U.S. Department  
of Transportation  
**Federal Highway  
Administration**

In Reply Refer To:  
HSSI/WZ-294

This is in response to your October 7 correspondence requesting the Federal Highway Administration's (FHWA) acceptance of a number of your company's portable sign stands with 60-inch x 60-inch roll up signs as crashworthy traffic control device for use in work zones and elsewhere on the National Highway System (NHS). Accompanying your letter was the FHWA Office of Safety Design form explaining that all the stands were found acceptable with 48-inch x 48-inch signs, but that the 60 x 60 signs would be affixed to the stands so that the top of the sign is at the same height as the 48 x 48 signs. You requested that we find these devices acceptable for use on the NHS under the provisions of National Cooperative Highway Research Program Report 350 "Recommended Procedures for the Safety Performance Evaluation of Highway Features."

This inquiry is in regards to our follow-up regarding the impact 60x60 roll-up signs would have on previously accepted stands. According to the clarification you provided regarding WZ-85, various sizes of roll-up signs can be accepted without re-testing.

# TALL STANDS

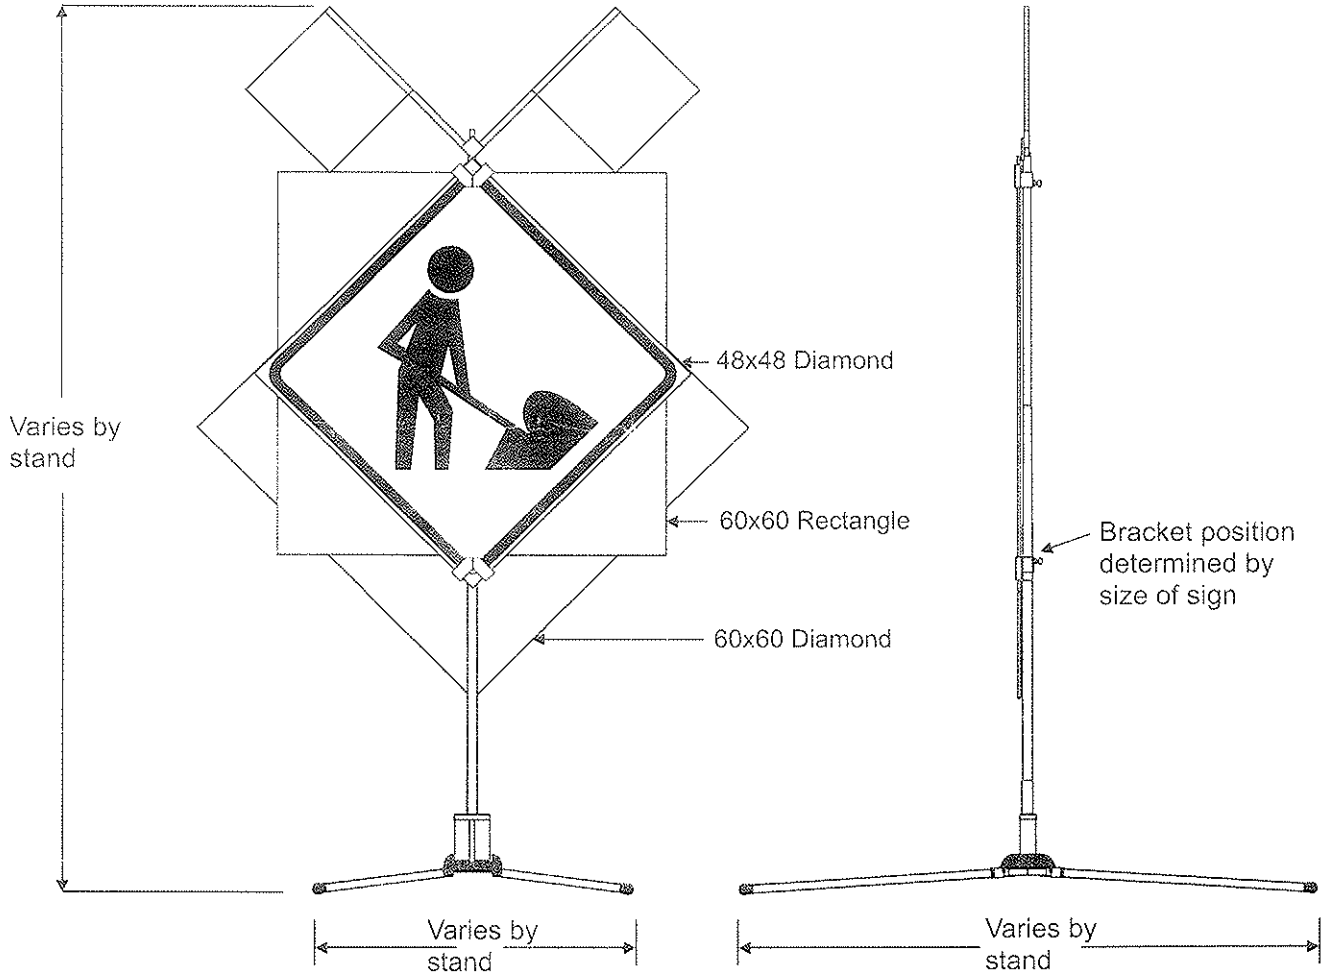
Based on the enclosed information and previous test data, we are seeking acceptance of the sign stands listed above for use with 60"x60" roll-up signs. We believe this to be a reasonable request because the

design differences all occur below the height of the vehicle bumper. As such, we contend that they will have no effect on the windshield impact data.

This letter is the acknowledgement of the FHWA's acceptance of your request. The original completed form has been modified by the addition of the FHWA acceptance letter number and the date of our review. The form, of which a copy is enclosed for reference, will be posted on our Web site in the near future.
